REV B

AS3119™

FEDERAL SUPPLY CLASS 5306

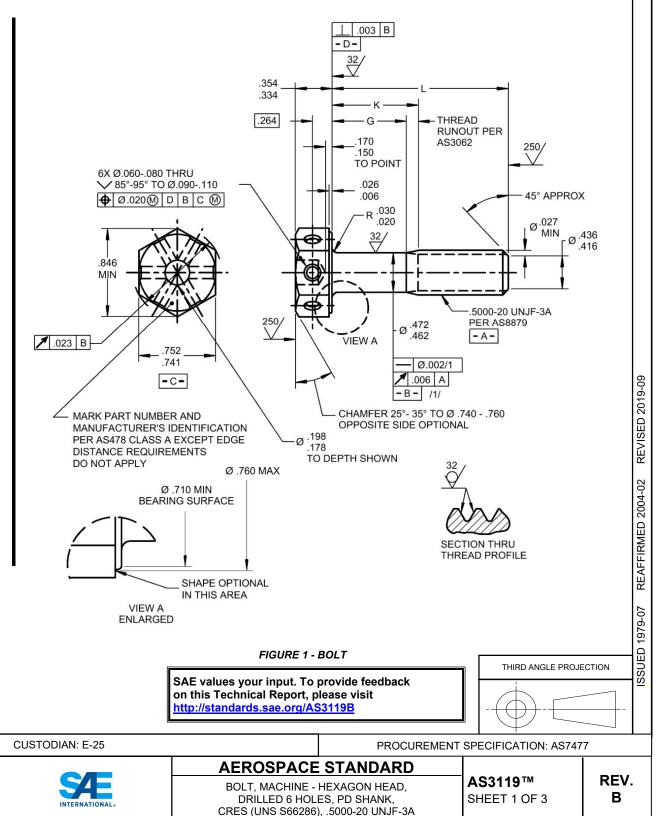
FIGURE 1 RE-DRAWN, EDGE DISTANCE EXCEPTION ADDED TO HEAD MARKING REQUIREMENT, TERTIARY DATUM ADDED TO POSITION REQUIREMENT FOR DRILLED HOLE, LEAD THREAD CHAMFER REVISED TO CURRENT AS1132, FPI NOTE UPDATED, NEW NOTE ADDED FOR DISPOSITION OF EXISTING INVENTORY, FOR P/N AS3119-47, CORRECT TYPOGRAPHICAL ERROR IN APPROX MASS, GENERAL EDITORIAL AND FORMATTING UPDATES.
